**CENTER FOR DRUG EVALUATION AND  
RESEARCH**

*APPLICATION NUMBER:*

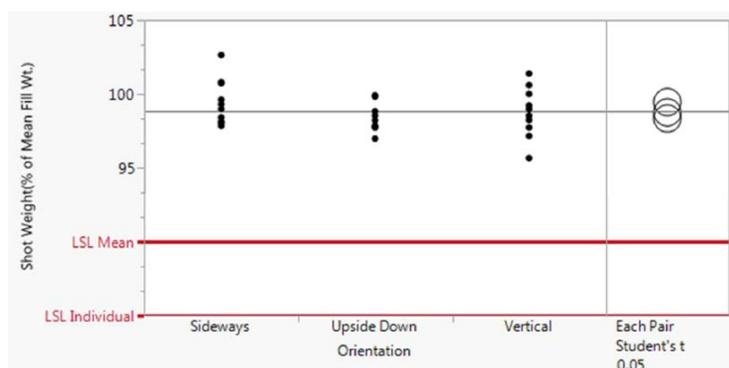
**Sponsor Response:**

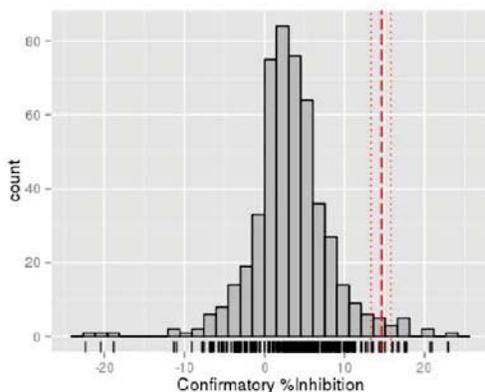
*Reviewers comments:*

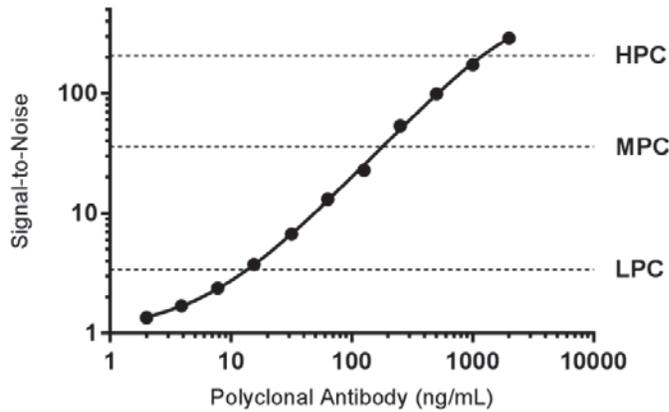
*Reviewers comments:*

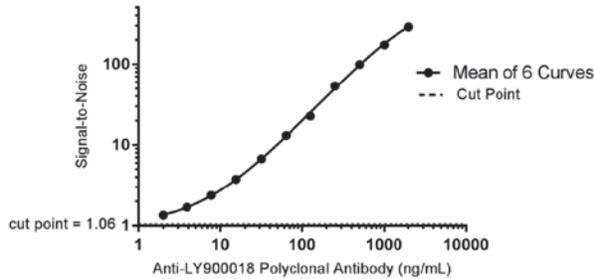
*Reviewers comments:*

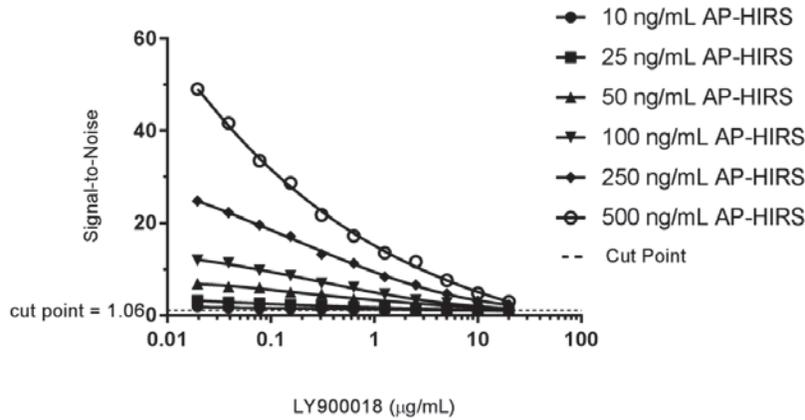
**Reviewers comments:**

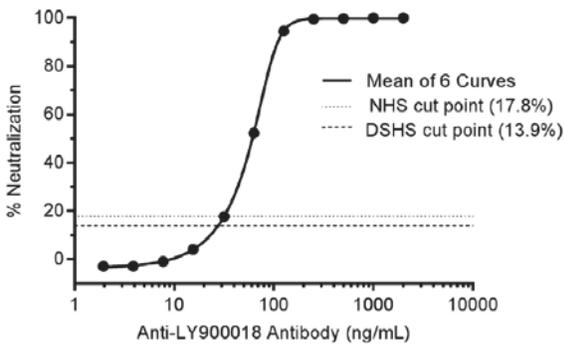
*Reviewers comments:*

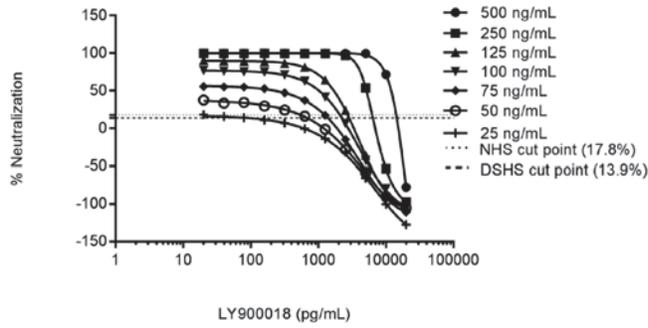
*Reviewers comments:*
